C02 25.04.24 ML NS Revised following Planning feedback C01 16.02.24 TF OB First Issue

Camden Town Hall Tenant Fitout

PROPOSED GROUND FLOOR PLAN

DRAWING NUMBER 242931-PUR-02-GF-DR-A-9201

PROPOSED GROUND FLOOR LEVEL PLAN 1:200 @ A I

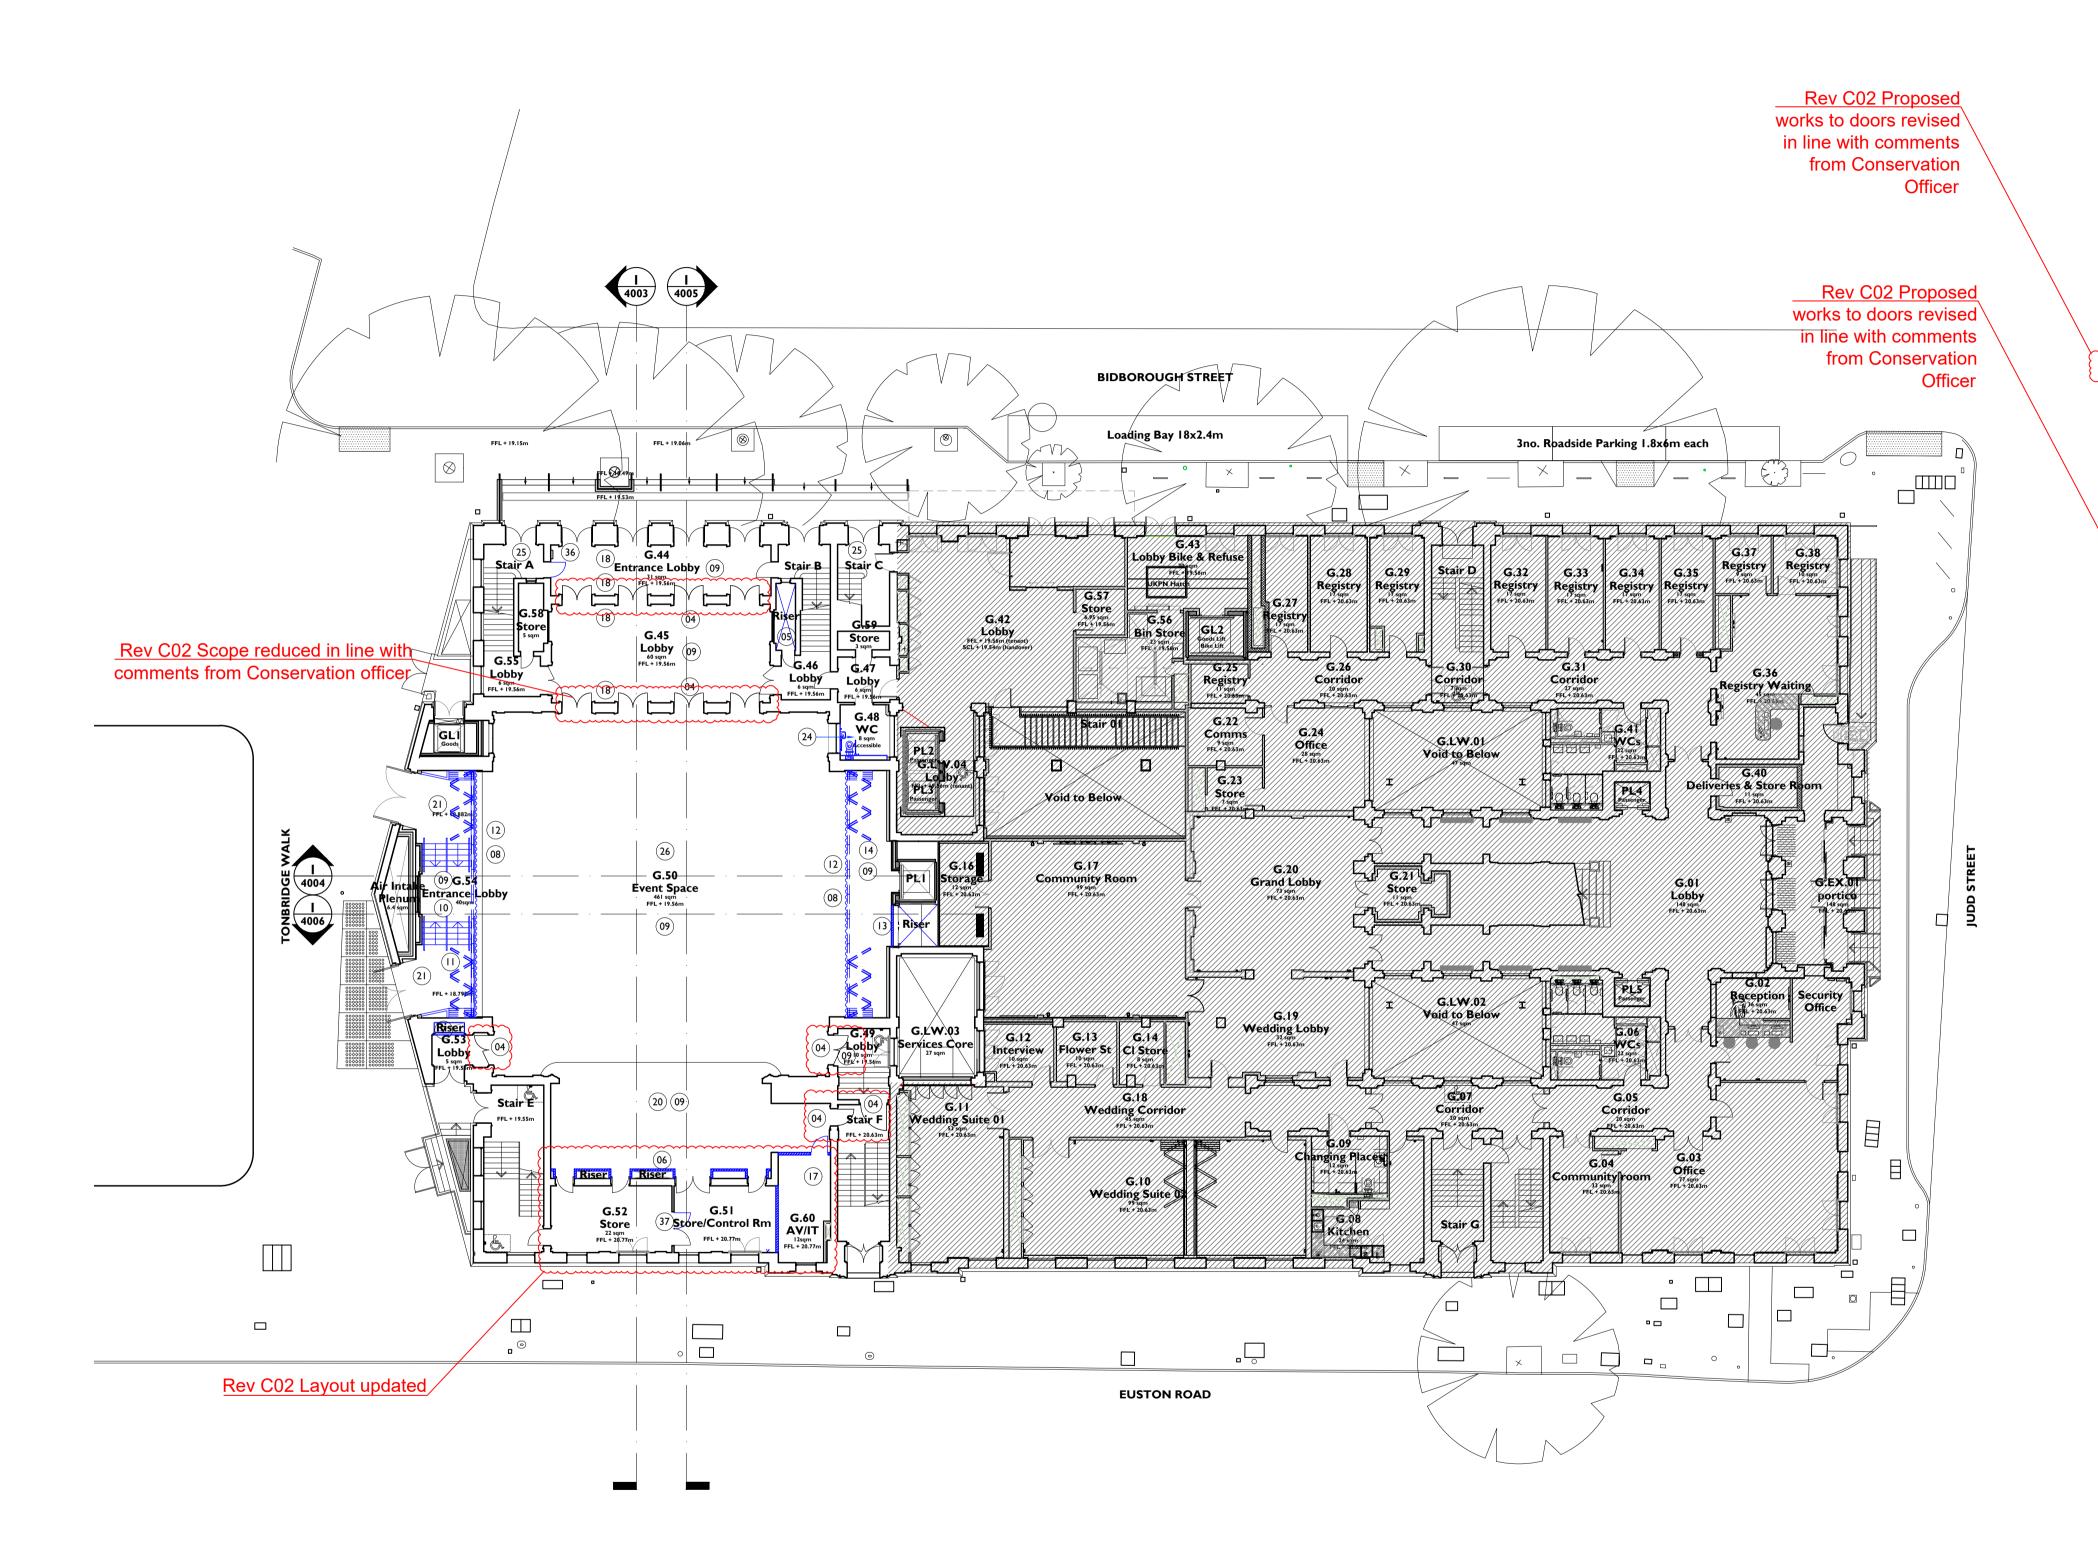
Rev C02 Proposed works to doors revised in line with comments from Conservation Officer
